DATE PREPARED: <b>June 13, 2007</b>		<b>ISS PAYLOAD OFFICE PIRN/EXCEPTION FORM</b>		<b>PAGE 1 OF 6</b>	
Doc. No., Rev. & Title: <b>SSP 57003, Revision C, Attached Payload Interface Requirements Document SSP 57213, Initial Release, Alpha Magnetic Spectrometer (AMS) Interface Control Document</b>		PIRN No:  <b>57213-NA-0010</b>			
TITLE: <b>AMS (Alpha Magnetic Spectrometer) – PVGF Clearance Intrusion</b>					
<b>Originator:</b> Name: <b>Trent Martin</b> Agency: <b>NASA JSC AMS Project Office / EA</b> Phone: <b>281-483-3296</b> Email: <b>trent.d.martin@nasa.gov</b>		PIRN Type: <input type="checkbox"/> Standard PIRN <input checked="" type="checkbox"/> Exception		FAX Approval Signatures to this Number: <b>314-777-2866</b>	
<b>Utilization Change Engineer:</b> Name: <b>Leonardo Cornejo</b> Agency: <b>Boeing PEI</b> Phone: <b>281-226-4644</b> Email: <b>leonardo.a.cornejo@boeing.com</b>		SSCN/CR <b>N/A</b>		RELATED PIRN No.: <b>N/A</b>

Agency Tracking No.: <b>57213-0005</b>		SYSTEM/ELEMENT AFFECTED & STAGE EFFECTIVITY: <b>AMS Launch through End Of Life</b>			
REASON FOR CHANGE OR REQUIREMENT(S) VIOLATION: <b>AMS PVGF clearance envelope requirement as defined in SSP-57003, Paragraphs 3.7.3.

**Figure 3.7.3.3.1-AMS-01: AMS PVGF Envelope Violation**  
**Dimensions in figure above are inches [mm]**

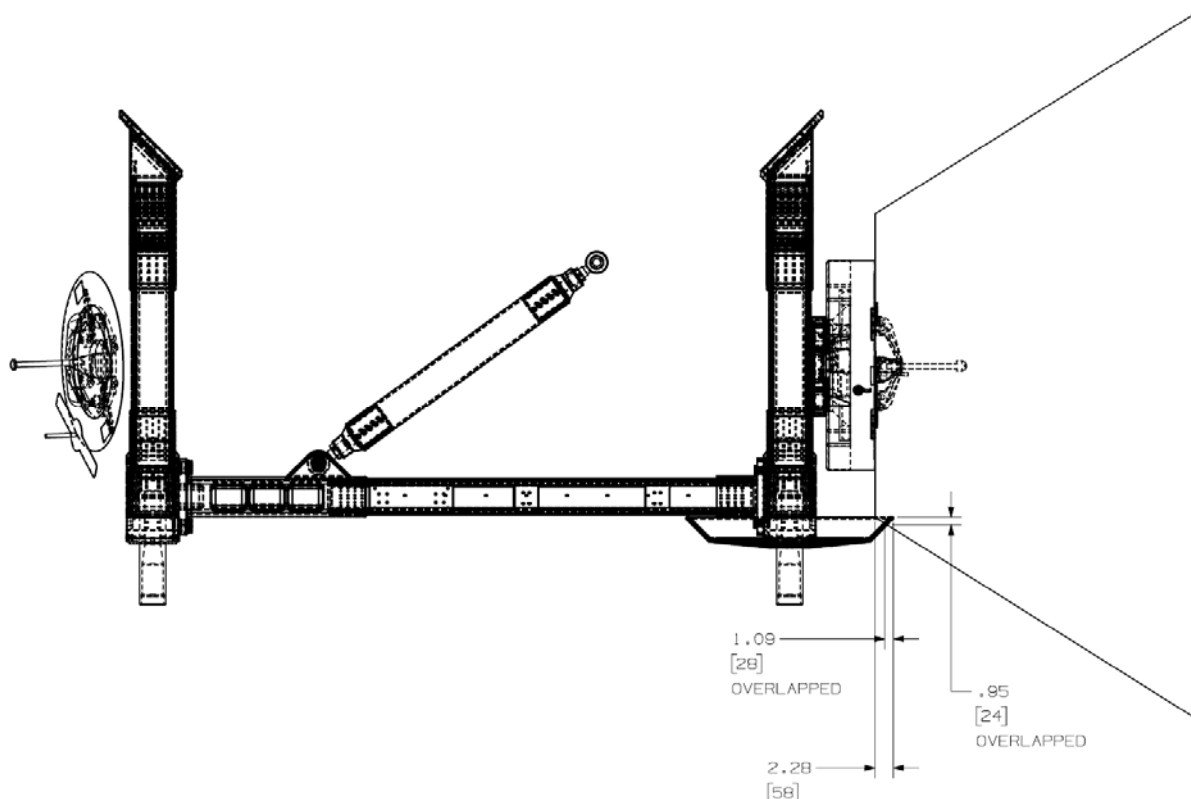
An Attached Payload requiring SSRMS support shall provide a clearance envelope as specified in SSP 42004, paragraph N3.2.2.1, **except for the AMS payload will have an intrusion as shown in Figures 3.7.3.3.1-AMS-01, 3.7.3.3.1-AMS-02, and figure 6 from MAGIK AI 2279.**

Scuff plate intrusion into the SSRMS static approach envelope is near the edge of the envelope at the point when the SSRMS would have captured the PVGF.

This small interference into the PVGF envelope appears to pose no concern for the SSRMS.

PEI agrees with the Rationale and with NASA ER3 concurrence provided via e-mail (attached) on November 19, 2008, which states: "ER concurs with the intent of the subject Exception. The clearance violation is at the base of the PVGF such that the LEE would have to drop to within approximately 1 inch of the PVGF base to incur the violation and contact the PRLA trunnion scuff plate".

Approve as written.

Approved as written.

**Figure 6: PVGF EVA Envelope with Violations by AMS Structure and EVA Handrails**

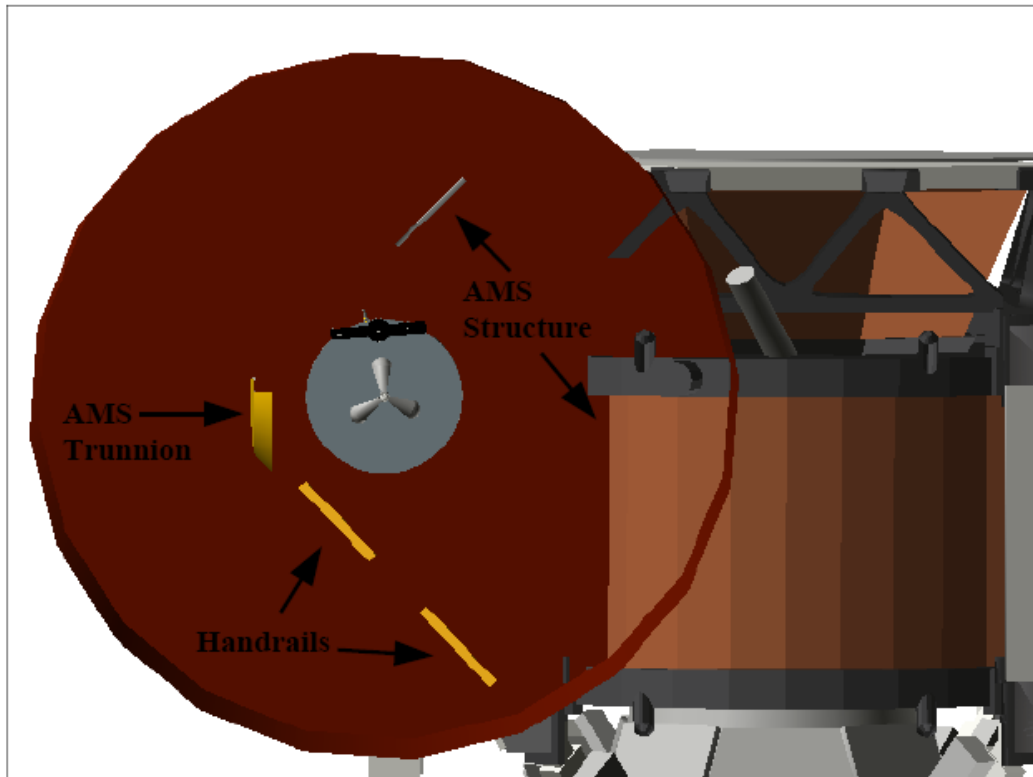
The AMS payload, along with the ISS office, have performed extensive analyses and testing of this envelope intrusion. The assessments have included MAGIK analyses of payload berthing (AI 1254, AI 1965, AI 2279), EVA worksite analyses (LMSO Q105743), and NBL test (Crew Consensus Report 11.12.02). Per Crew Consensus Report (AMS NBL 11.12.02), EVA access to the PVGF contingency release bolt is acceptable.

**Figure 3.7.3.3.1-AMS-03: AMS Scuff Plate and SSRMS LEE**

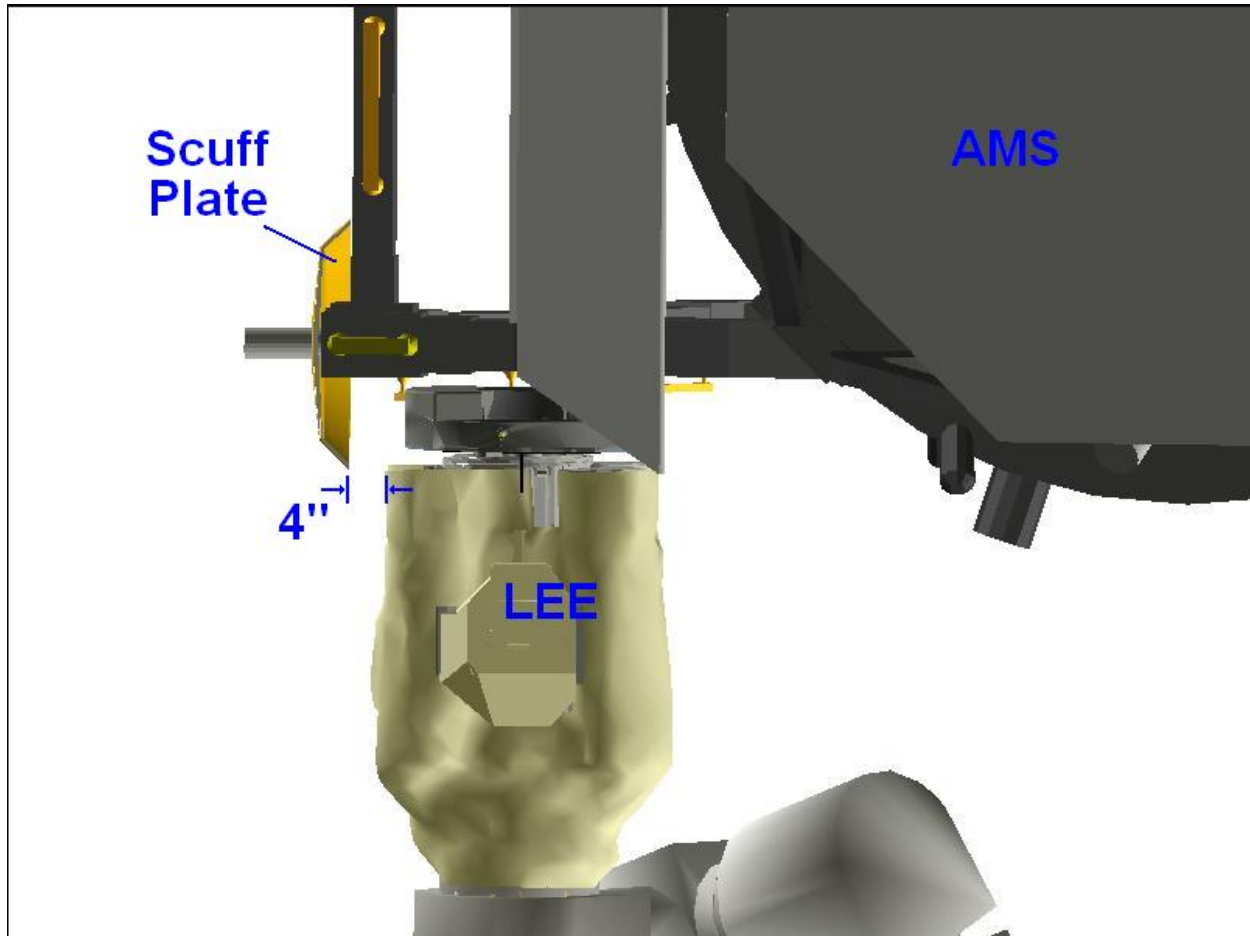
MAGIK provided figure 3.7.3.3.1-AMS-03 shows 4 inches separation between the AMS scuff plate and the SSRMS Latching End Effector (LEE) when the LEE is attached to the AMS PVGF. This confirms that the AMS scuff plate intrusion into the PVGF SSRMS LEE approach envelope does not prevent the SSRMS LEE operation with the AMS PVGF.
